Access Compliance Report

Public Rights-of-Way

(Curb Ramps)

Intersection ID: 46819	Main Street: CLAUDE FREEMAN DR	Cross Street: AZALEA HILLS DR	Location: SW
ADA ID: E3A51B619B15	Ramp Type: Perp	Initial Pass/Fail: Pass	Overall Compliance: No
			Severity Score: 10

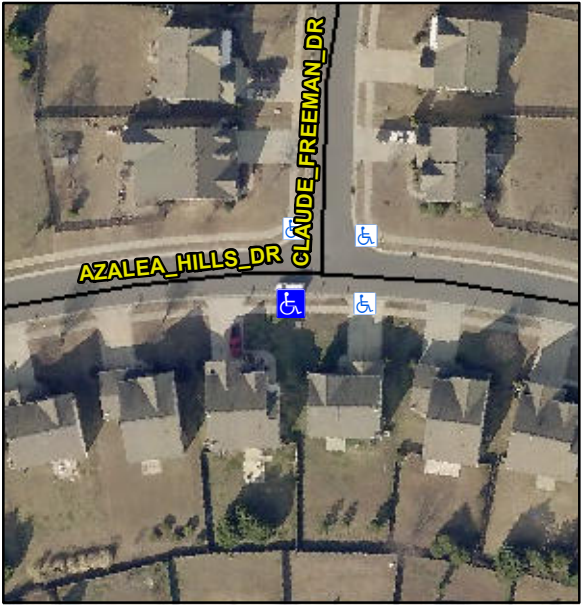
Codes/Mitigation Info/Possible Solution			Field Measurements/Component Compliance		
	Possible Solutions:		Compliance	Description	Data
	Remove & Replace Entire Ramp.		Yes	Ramp Length (in)	49.0
			Yes	Ramp Width (in)	49.0
			N/A	Flare Type LT	Sloped
			N/A	Flare Slope LT (%)	6.3
			N/A	Flare Traversable LT?	Yes
			Yes	Landing Length (in)	49.0
			Yes	Landing Width (in)	63.5
			Yes	Landing Slope (%)	0.7
			Yes	Landing X Slope (%)	0.7
<p>Surveyor Notes:</p> <p>N/A</p> <p>PROW/ADA:</p> <p>Not Found, R305</p>			N/A	Flare Type RT	N/A
			Yes	Flare Slope RT (%)	9.0
			N/A	Flare Traversable RT?	Yes
			No	DWS Provided?	No
			N/A	DWS Contrast?	No
			N/A	DWS Length (in)	N/A
			N/A	DWS Full Width?	No
			N/A	DWS Offset (in)	N/A
			No	Gutter Ponding?	No
			Yes	Gutter Lip Ht (in)	0.0
<p>Total Cost:</p> <p>\$ 1850.00</p>			N/A	Painted X Walk1?	No
			N/A	X Walk 1 Direction	To N
			N/A	X Walk 1 Width (in)	N/A
			N/A	X Walk 1 Slope (%)	2.7

N/A	X Walk 1 X Slope (%)	1.2
			N/A	Ramp inside XWalk1?	N/A
			N/A	Road Slope (%)	N/A
			N/A	Road X Slope (%)	N/A
			Yes	Any Obstructions?	No
				Obstruction Type	
			N/A	X Walk 2 Direction	N/A
			N/A	X Walk 2 Width (in)	N/A
			N/A	X Walk 2 Slope (%)	N/A
			N/A	X Walk 2 X Slope (%)	N/A
			N/A	Ramp inside XWalk2?	N/A
			N/A	Clear Space?	Yes
			N/A	Clear Space to XWalk (in)	N/A
			Yes	Storm Grate/Utility Hazard?	No
				Storm Grate/Utility Type	
			N/A		N/A
			Yes	Surface Condition? (G/P)	Good
